SUBJECT: RFI #13 – Chilled Water Pipe Size Change

BULLETIN 04

PROJECT: Cornell University Balch Hall Renovation

SK4.1

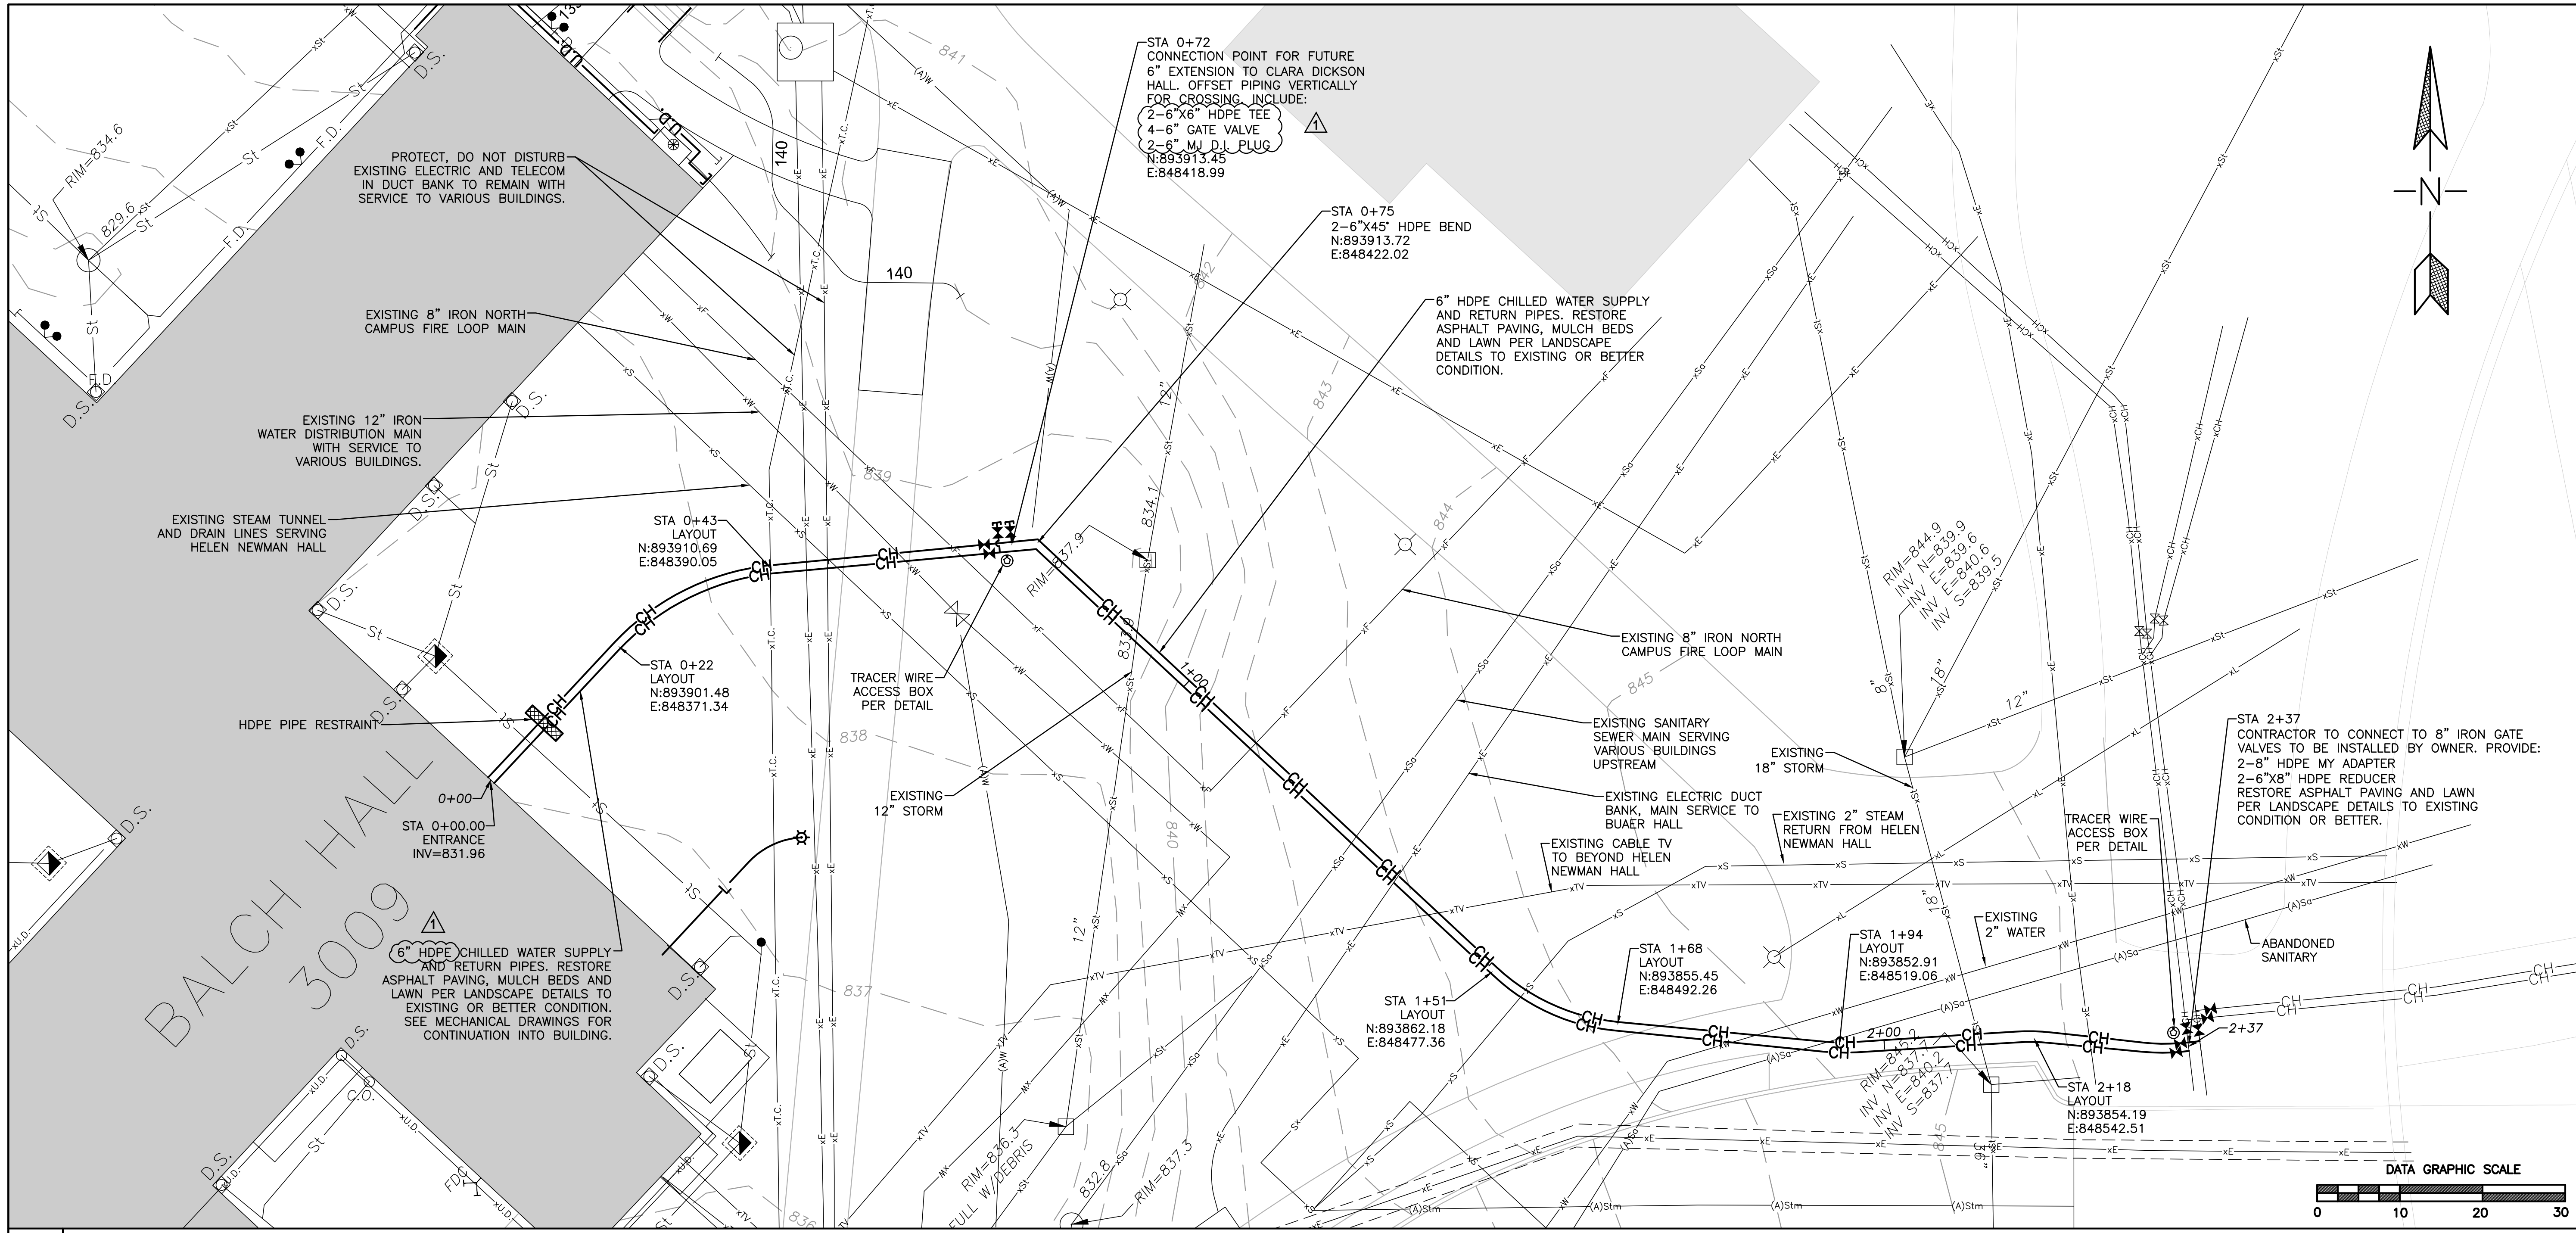
Origin: Due to differing sizes on multiple drawings, RFI 0013 requested clarification regarding the size of a chilled water pipe entering the building. The pipe was revised to be a 6” pipe.

6" HDPE CHILLED WATER SUPPLY AND RETURN PIPES. RESTORE ASPHALT PAVING, MULCH BEDS AND LAWN PER LANDSCAPE DETAILS TO EXISTING OR BETTER CONDITION. SEE MECHANICAL DRAWINGS FOR CONTINUATION INTO BUILDING.

STA 0+72
 CONNECTION POINT FOR FUTURE
 6" EXTENSION TO CLARA DICKSON
 HALL. OFFSET PIPING VERTICALLY
 FOR CROSSING. INCLUDE:
 2-6"x6" HDPE TEE
 4-6" GATE VALVE
 2-6" MJ D.I. PLUG
 N:893913.45
 E:848418.99

C2.03

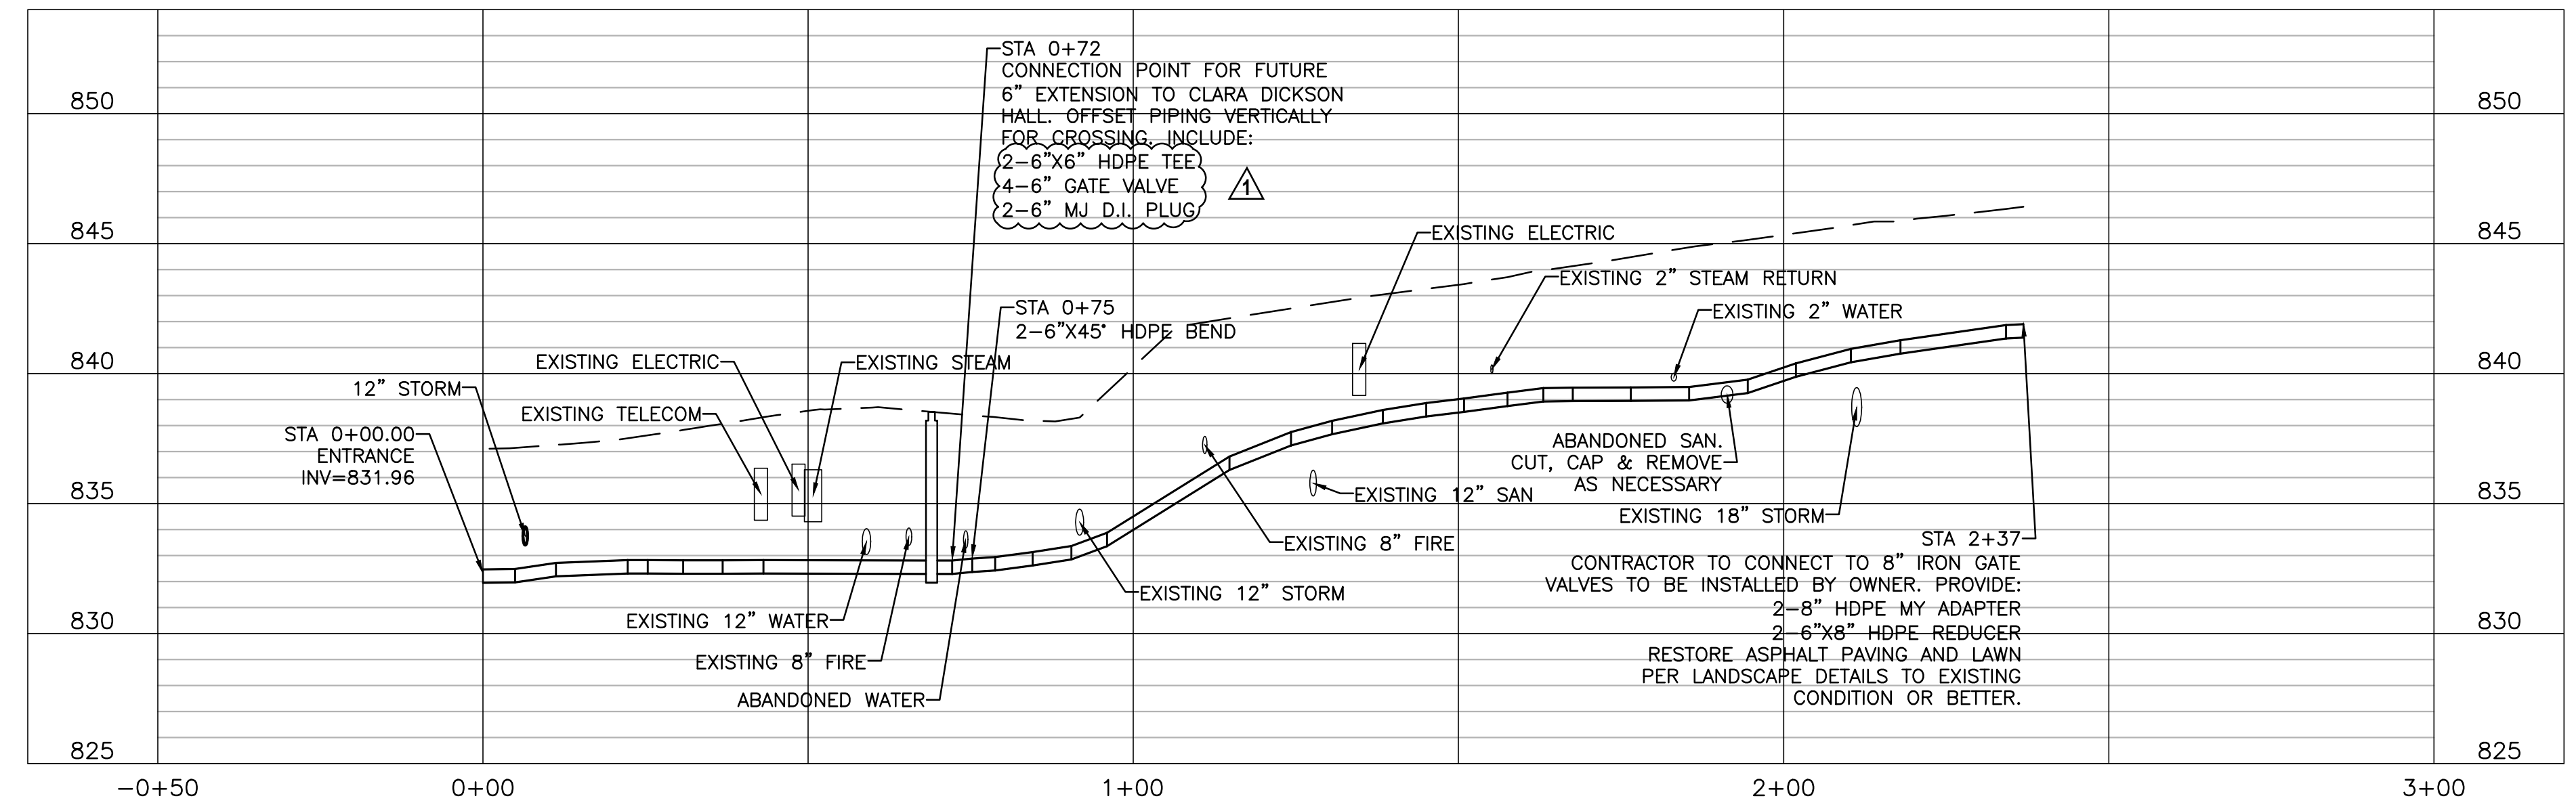
C2.03

- Size of cold water pipe changed to 6”
